WESTERN AREA PLANNING COMMITTEE 21ST FEBRUARY 2024

UPDATE REPORT

ltem No:	(3)	Application No:	23/00373/RESMAJ	Page No.	93-109	
Site:	Land Off Lambourn Road Speen Newbury

Extent of public rights of way on the dismantled railway

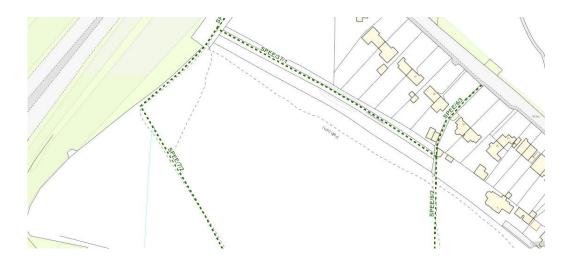
During the site visit Members queried the extent of the public right of way on the dismantled railway. The applicant also emphasised that the dismantled railway and public rights of way is outside the application site. The public right of way network area, informal paths and the dismantled railway strip are shown on the map below.
